Re: City of Schertz Animal Center
HVAC Installation
Bid Number: # 4016

3.2 Review of DBR’s Comprehensive Repair Plan

Figure 241: Unconditioned Outdoor Air Ducted to Indoor Units.

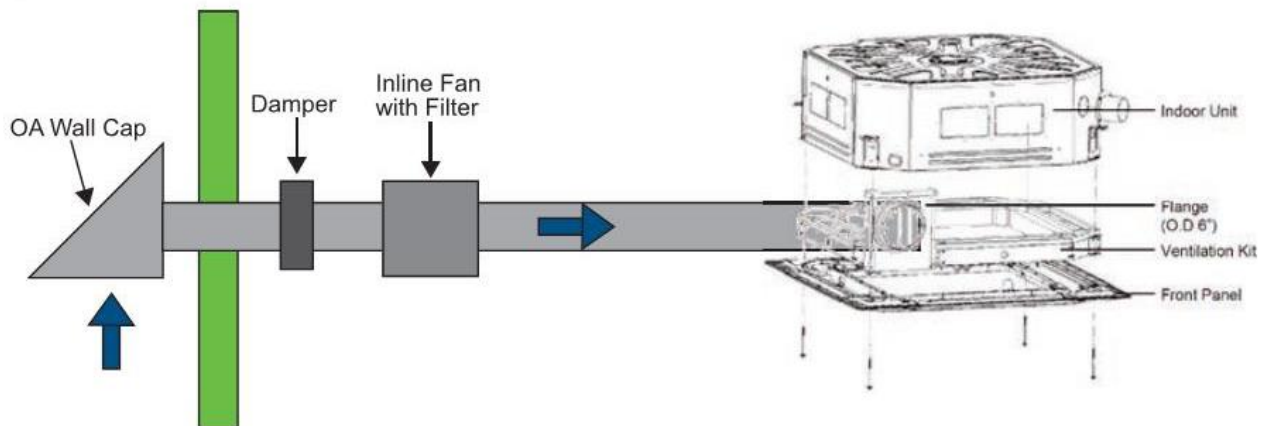
Outside air may flow backward through the return air-filter grille when the indoor unit fan speed slows or stops in response to changes in the space load. This may result in captured particulate on the filter media being blown back into the conditioned space.

- Fan(s) will be required to push outdoor air to the indoor unit to overcome the additional static pressure.
- Filter required to be added to the outdoor air duct.
- Ducted and four-way cassette models are the only indoor units that accept the connection of an outdoor air duct to the unit case.
- In most cases, in lieu of using the factory mounted return-air thermistor on indoor units, a remote wall temperature sensor or zone controller will be needed to provide an accurate reading of the conditioned area temperature.
- Unconditioned outdoor air may affect indoor unit performance, which may necessitate oversizing the indoor unit.
